**THIRD AMENDMENT TO AGREEMENT NO. 2021-41 PROFESSIONAL ENGINEERING SERVICES FOR
CRANBERRY BOULEVARD/HILLSBOROUGH BOULEVARD INTERSECTION IMPROVEMENTS DESIGN &
PERMITTING FOR WESTERN LEG OF ROUNDABOUT DESIGN MODIFICATIONS TO SCOPE AND PRICE**

Task 14 – West Approach Redesign

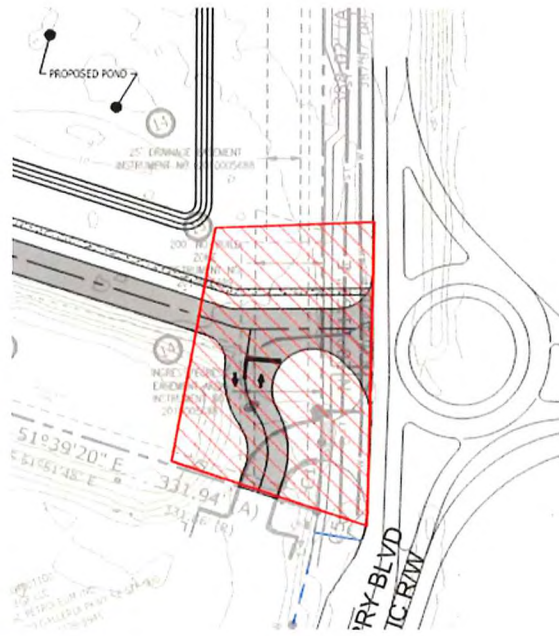
At the Client’s request, Kimley-Horn will redesign the west approach of the Roundabout, as highlighted in the graphics below, to account for AdventHealth and RaceTrac entrance redesign.

Kimley-Horn will redesign the west roundabout approach in accordance with governing standards established in the Agreement. Kimley-Horn will analyze the revised

approach geometry for criteria compliance consisting of fastest path and design vehicle turning movement (swept path) performance measures.
